AEROPRAKT

SERVICE BULLITEN

No. SB A-32-02

Modification of the all-moving horizontal tail (AMHT) of A32 aircraft.

Fig. 1

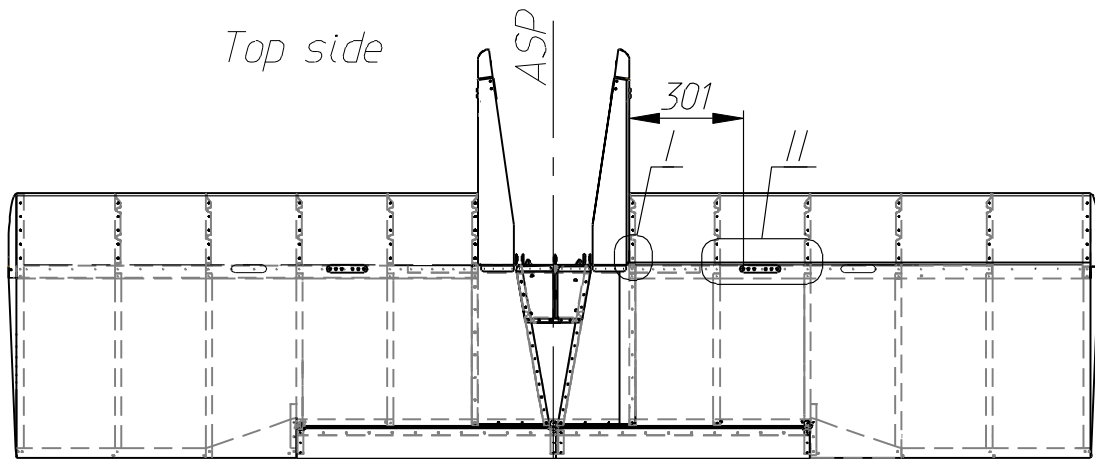
Inspect the AMHT in the area of mod kit parts installation (see detail views II and IV in fig. 1 and 2) for dents, deformation and cracks. If any damage is found in the above mentioned areas consult the manufacturer.

- 1.1. Mark 2 holes (1 per righthand/lefthand side) on the top side of the AMHT at 301 mm distance as shown in fig. 1 and 3.
- 1.2. Drill the 2 marked holes with &3.3 mm drill bit.
- 1.3. Install the doublers (1) on Cleco fasteners symmetrically about the aircraft symmetry plane (ASP).

Fig. 3

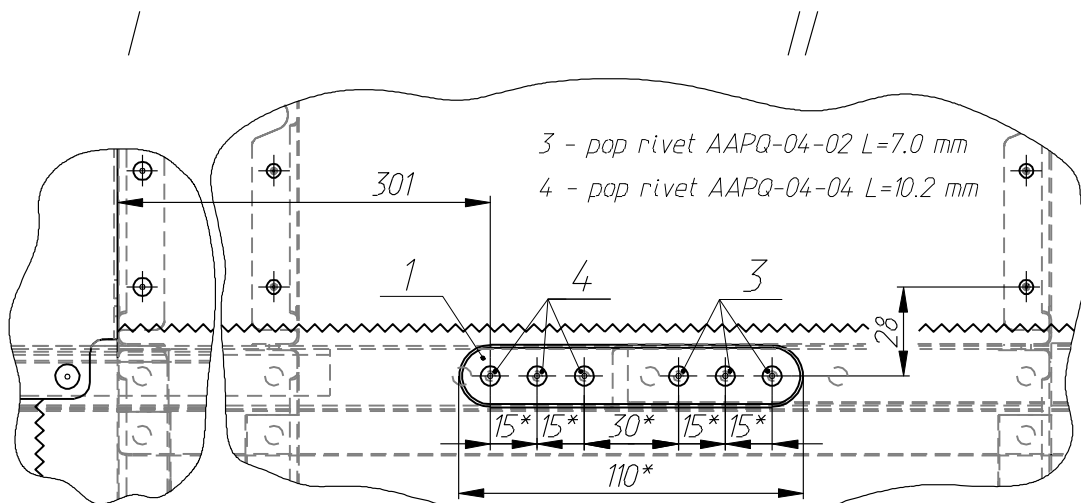
- 1.4. Using the holes in the doublers as pilot holes drill $\&3.3$ mm holes – 5 holes on each (righthand/lefthand) side.
- 1.5. Remove the doublers, deburr/blunt the sharp edges of the holes, remove the metal chips.
- 1.6. Attach the doublers with pop-rivets (3) and (4) as shown in fig. 3 (symmetrically about the ASP).

Fig. 4

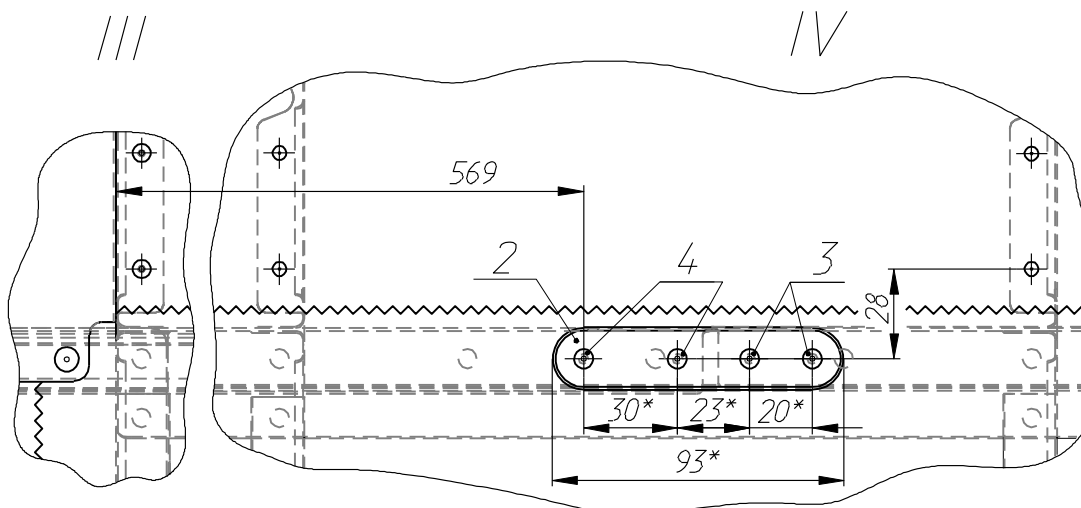
2. Installation of the bottom (righthand and lefthand) doublers:
 - 2.1. Mark 2 holes (1 per righthand/lefthand side) on the bottom side of the AMHT at 569 mm distance as shown in fig 4.
 - 2.2. Drill the 2 marked holes with $\&3.3$ mm drill bit.
 - 2.3. Install the doublers (2) on Cleco fasteners symmetrically about the ASP.
 - 2.4. Using the holes in the doublers as pilot holes drill $\&3.3$ mm holes – 3 holes each (righthand/lefthand) side.
 - 2.5. Remove the doublers, deburr/blunt the sharp edges of the holes, remove the metal chips.
 - 2.6. Attach the doublers with pop-rivets (3) and (4) as shown in fig. 3 (symmetrically about the ASP).
